From: Holm, Anchor <aholm@slo.state.nm.us>
Sent: Wednesday, March 06, 2013 3:07 PM
To: Bratcher, Mike, EMNRD; Warnell, Terry G.
Subject: Proposed New Well at Cedar Lake
Attachments: Cedar Lake - New Proposed Well with alternate site.pdf

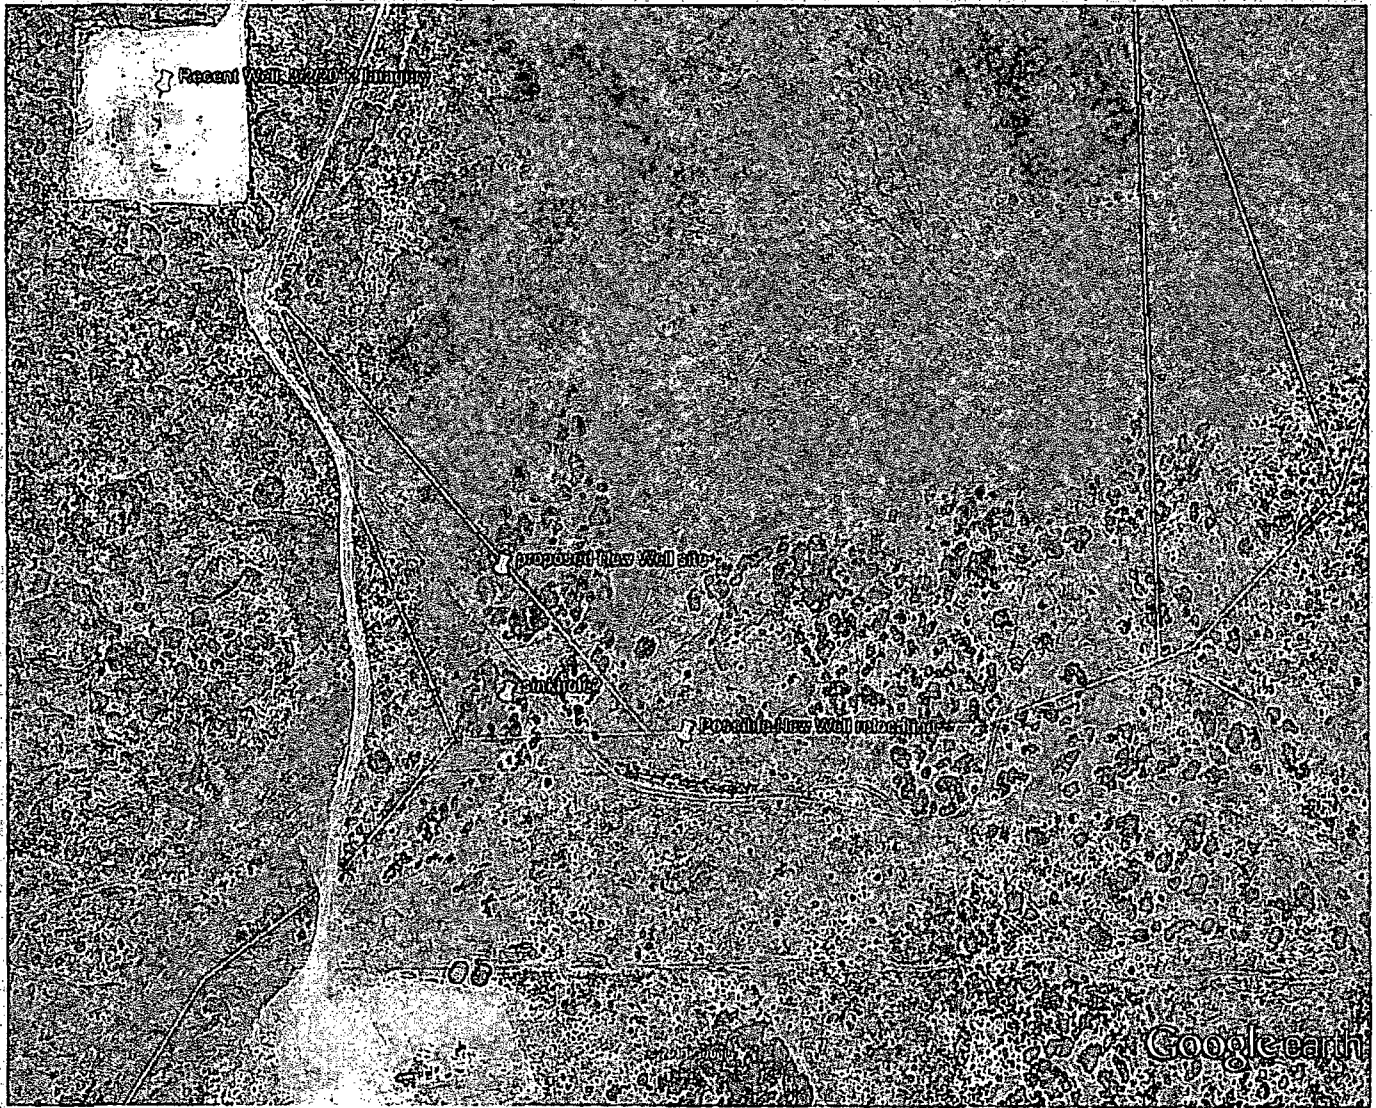
Attached is the scanned 3-2-2012 Google Image with the location of the currently proposed New Well marked. This is based upon the lat.long. given to Terry.

It appears that this well site is within the throat of the floodway/spillway from Cedar Lake. Upon review of this image, I suggest that the location be moved about 340 feet to the SE. It is marked as the "Possible New Well relocation". This relocated site should be at least as far away from the high water mark of Cedar Lake as the Recent Well, also shown on this image.
